Subject: WATER ENTRY FROM THE REAR DOOR	Bulletin No.: 09-039/20
	Last Issued: 12/17/2020

2019-2021 Mazda3

2020-2021 CX-30

DESCRIPTION

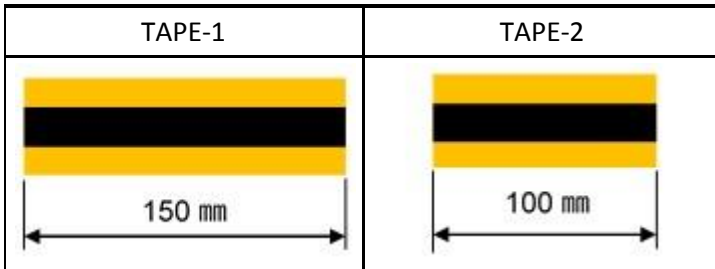
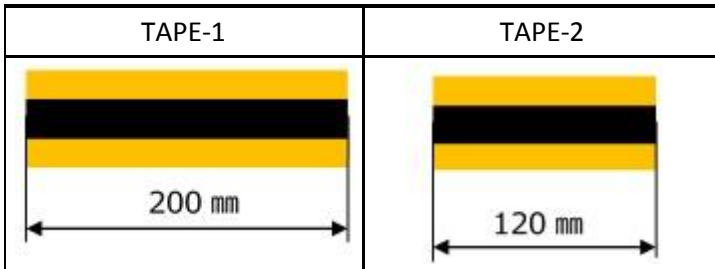
a. Cut butyl tape to the following sizes:

NOTE: Use butyl tape with a width=1/4 in (6.4mm) and thickness=1/8 in (3.2mm).

Mazda3	CX-30
TAPE-1: 6 in (150mm) x 1pc.	TAPE-1: 8 in (200mm) x 1pc.
TAPE-2: 4 in (100mm) x 1pc.	TAPE-2: 4-3/4 in (120mm) x 1pc.

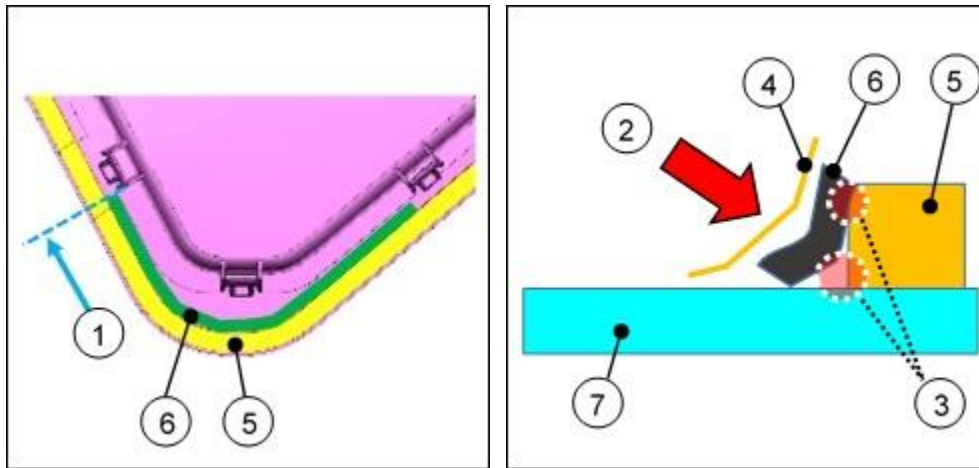
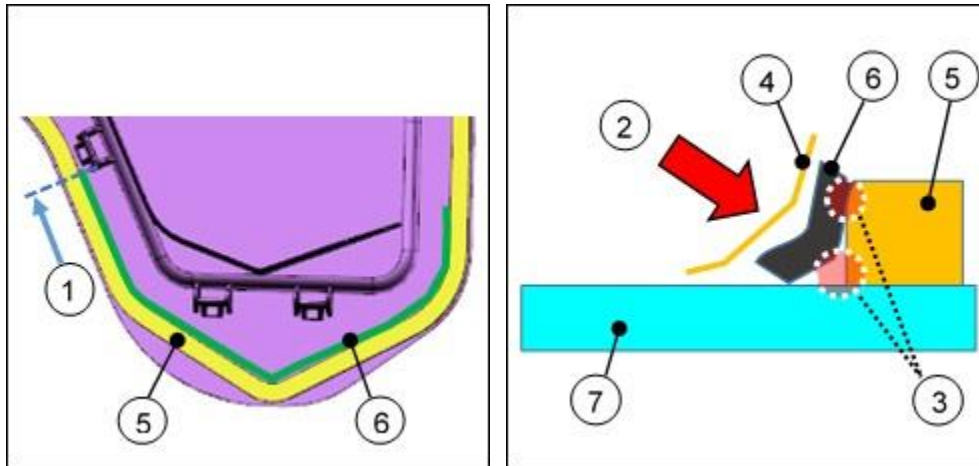
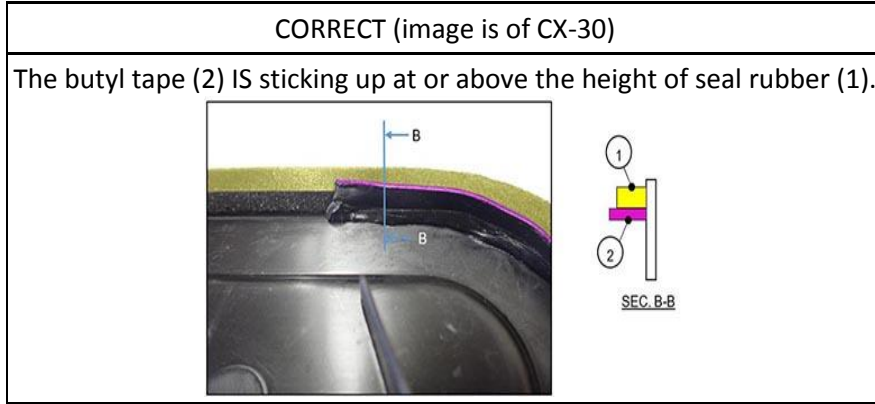
c. Apply TAPE-1 (6) as per the green line below along with the seal rubber (5). **NOTE:**

- Using water on your hands will make working with the butyl tape easier as the tape will not stick to hands with water on them.
- Be careful not to apply TAPE-1 to the front part of the tabs as it is difficult to apply TAPE-1 near the tabs.

1) Start applying TAPE-1 (6) at the edge (1) of the tab.

2) Using the release paper (4), press the tape hard (2) to fill the gap (3) between TAPE-1 (6) and the seal rubber (5) / service hole cover (7).

Mazda3

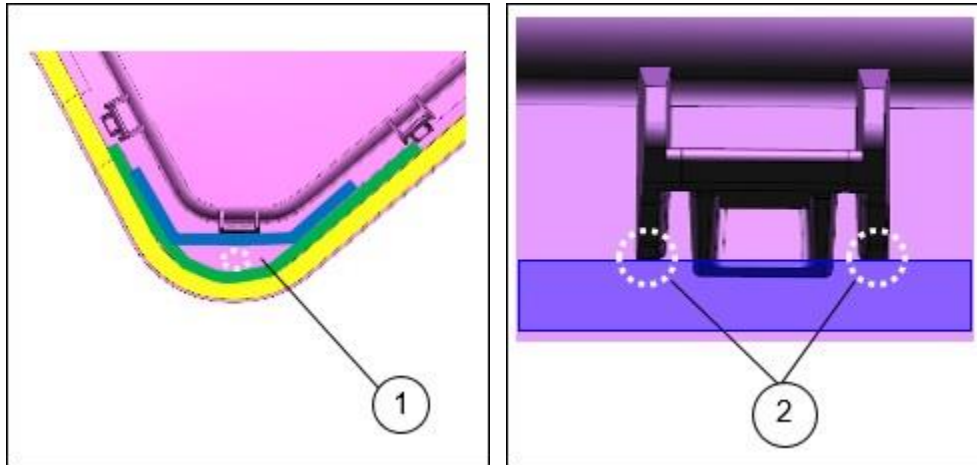
d. Apply TAPE-2 as per the blue line below.

- DO NOT fill area (1) to avoid blocking the drain hole on the door panel.
- Apply TAPE-2 along the bottom edge of the ribs (2) of the tab.
- Make sure TAPE-1 and TAPE-2 make good contact with each other when they overlap.

CX-30

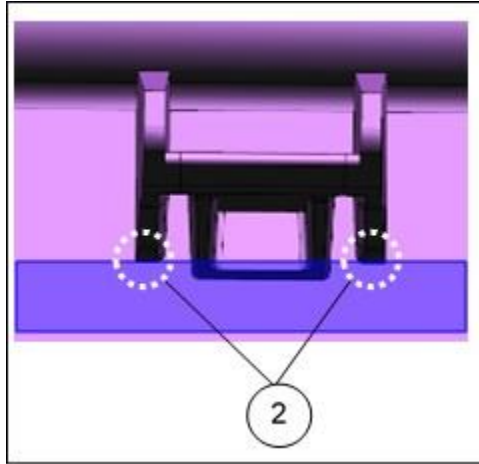
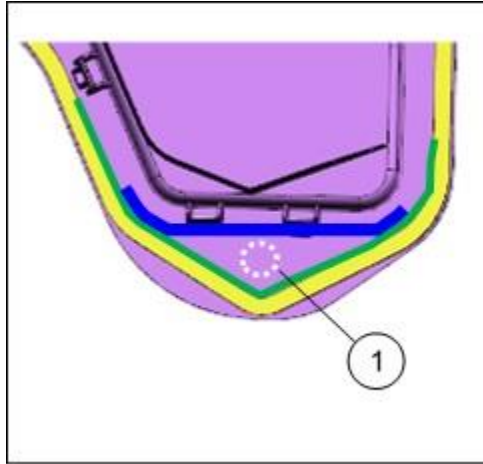
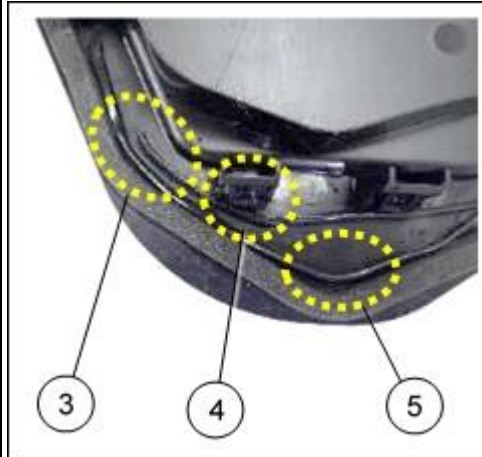
Examples of NOT CORRECT placement of tapes (image is of CX-30)	
	<p>(3) TAPE-2 does not adhere to TAPE-1. (4) TAPE-2 is away from the tab. (5) TAPE-1 does not adhere to the seal rubber.</p>

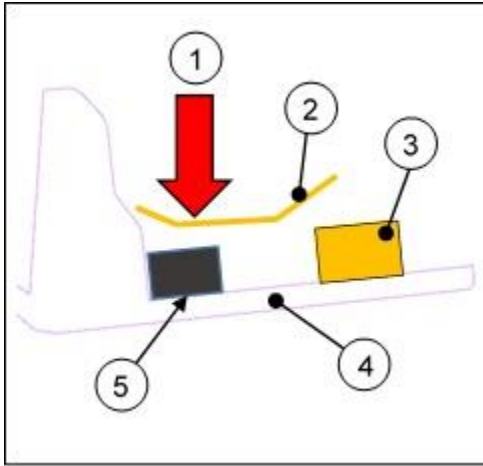
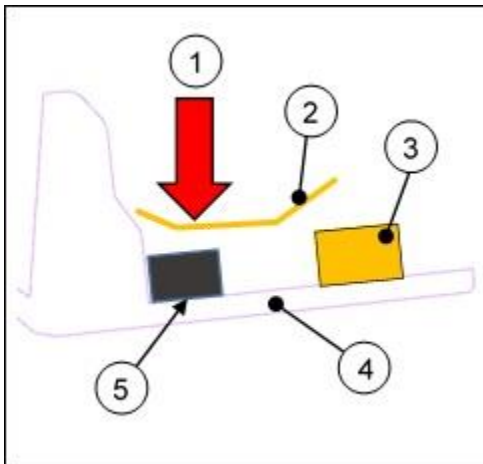
e. Press (1) the release paper (2) against TAPE-2 (5) to adhere the butyl tape to the service hole cover (4) [seal rubber (3)].
